DESIGN DS	DRAWN BY DS	DART AEROSPACE LTD HAWKESBURY, ONTARIO, CANADA	
CHECKED CP	APPROVED KE	DRAWING NO. DEO 9163	REV. A SHEET 1 OF 1
DATE 99.09.16		TITLE DZ650-3 LENGTH CHANGE	SCALE NTS
A	99.09.16	NEW ISSUE (REF. NCR 288)

DART ENGINEERING ORDER

TO AMEND DWG DZ650 REV. C

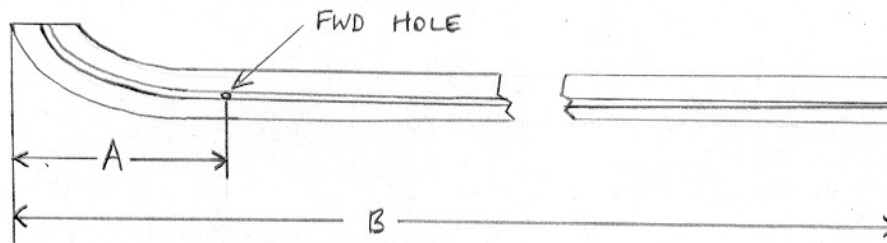
THE PURPOSE OF THIS ENGINEERING ORDER IS TO CLARIFY THE OVERALL LENGTH OF THE DZ650 SKIDTUBES AND TO CORRECT THE LENGTH OF DZ650-3 TO MATCH THE PARTS BEING MANUFACTURED.

<u>SKIDTUBE</u>	<u>ASSEMBLY</u>	<u>A</u>	<u>B</u>
DZ650-1	D206-642-141	19.1	96.45
DZ650-3	D206-642-241	20.1 (WAS 19.1)	104.45 (WAS 103.45)
DZ650-5	D206-642-341	19.1	117.35
DZ650-7	D206-642-441	19.1	138.60
